APPLICANT: W&H Investments, LLC	PETITION NO:	Z-11
(404) 372-5739	HEARING DATE (PC):	03-04-14
REPRESENTATIVE: Skip Harper	HEARING DATE (BOC): _	03-18-14
(404) 372-5739	PRESENT ZONING:	R-20
TITLEHOLDER: Estate of Oliver M. Bridges		
	PROPOSED ZONING:	R-15/OSC
PROPERTY LOCATION: East side of Hicks Road, south of		
Pioneer Trail.	PROPOSED USE: Reside	ntial Subdivision
(3275 Hicks Road).		
ACCESS TO PROPERTY: Hicks Road	SIZE OF TRACT:	20.756 acres
	DISTRICT:	17
PHYSICAL CHARACTERISTICS TO SITE: Single-family house	LAND LOT(S):	20, 21
and undeveloped acreage	PARCEL(S):	1
	TAXES: PAID X D	UE
CONTIGUOUS ZONING/DEVELOPMENT	COMMISSION DISTRICT	: 4

APPLICANT:	W&	H Investme	nts, LLC		PETITION NO.:	Z-11
PRESENT ZONI	NG:	R-20			PETITION FOR:	R-15/OSC
* * * * * * * * * *	* * * *	* * * * * * *	* * * * * * *	* * * * * * *	* * * * * * * * * * * * * * *	* * * * * * * * * *

The applicant is requesting a rezoning from R-20 to R-15/OSC for purpose of residential subdivision. The 20.756 acre site is located on the east side of Hicks Road, south of Pioneer Trail.

Z-11

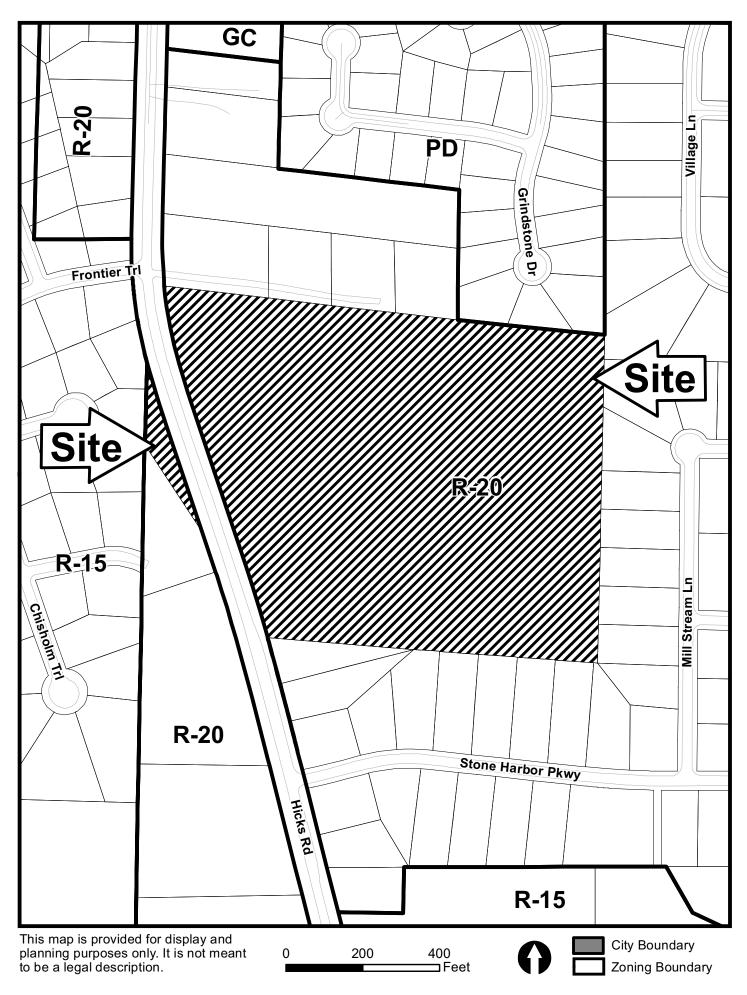
Applicant's revised site plan received on January 31, 2014 indicates 8.2 acres as open space. In addition, the site plan indicates a 20-foot rear setback on exterior lots and a 25-foot exterior landscape buffer.

- 1. Overall residential development shall be compatible with neighboring residential uses. In areas where adjoining neighborhood lots are larger, such as lots 1 8 and 30 34, the plan should incorporate larger lots adjacent to the existing neighborhoods with smaller lots to the interior. There is a 25' open space buffer to assist in mitigating the compatibility concerns
- 2. Natural walking trail must be constructed of pervious material.
- 3. Must have Cobb Department of Transportation approved lighting plan if outdoor lighting (except individual residential lots) is proposed

- No Stormwater controls shown
- Copy of survey is not current Additional comments may be forthcoming when current site conditions are exposed.
- No site improvements showing on exhibit.

- Revised site plan received by the Zoning Division on January 31, 2014, with the District Commissioner approving minor modifications;
- Fire Department comments and recommendations;
- Planning Division comments and recommendations;
- Water and Sewer Division comments and recommendations;
- Stormwater Management Division comments and recommendations; and
- Department of Transportation comments and recommendations.
